REVISED RESPONSE TO REQUEST FOR ADDITIONAL INFORMATION

APR1400 Design Certification

Docket No. 52-046

RAI No.: 199-8223
SRP Section: 03.08.01 – Concrete Containment
Application Section: 03.08.01
Date of RAI Issue: 09/08/2015

Figure 1 Radial or Vertical Displacements of RCB under Internal Pressure, Nonlinear Analysis Results for UPC Evaluation (Dot line: APR1400, Solid line: SKN34)

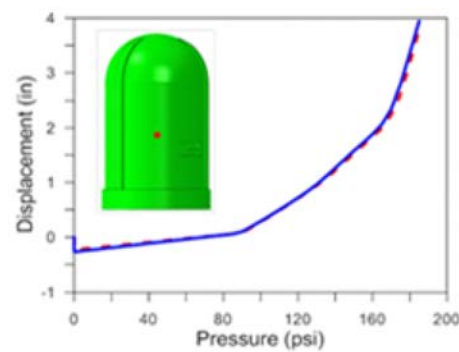
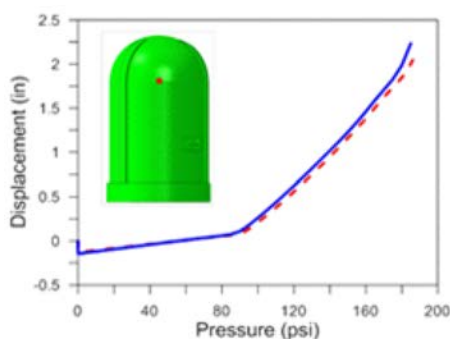
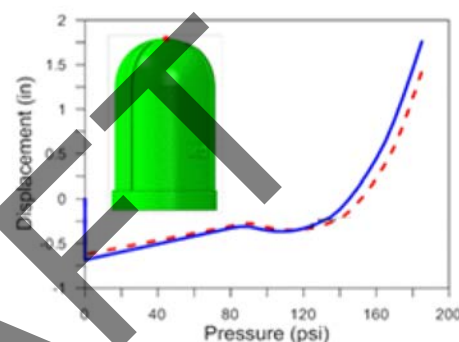
- a. DCD Tier 2, Section 3.8.1.7.1, "General Requirements," does not identify whether this containment is considered a prototype containment. DCD Tier 2, Section 3.8.1.7.1, "General Requirements," does not identify whether this containment is considered a prototype containment. It is believed that containment designed to ASME Subsection CC, incorporating new or unique design features not yet confirmed by tests are supposed to be designated as prototype containment. Thus, the applicant is requested to address whether this containment is designated as a prototype design and if not, explain why not. If it is a prototype containment, Section 3.8.1.7.1 of the DCD should be updated accordingly and explain that the additional provisions applicable to prototype containments in ASME Subsection CC, Article CC-6000 are implemented.

- a. The structural configuration of the reactor containment building (RCB) of the APR1400 is identical, with the exception of wall thickness, with that of Shin-Kori Unit 3, which has been tested and verified as a prototype. Therefore, the RCB of the APR 1400 is classified as a non-prototype containment, according to ASME Section III, Div.2, Subarticle CC-6150.

In addition, there is a comparison between APR1400 and Shin-Kori Units 3&4 under ultimate pressure. The static behavior and ultimate pressure capacity (UPC) of the APR1400 RCB under internal pressure is almost the same as those of Shin-Kori Units 3&4. The increased wall thickness affects the ultimate pressure capacity of the RCB, but the behavior of both NPP RCBs is almost the same, as shown in Figure 1.
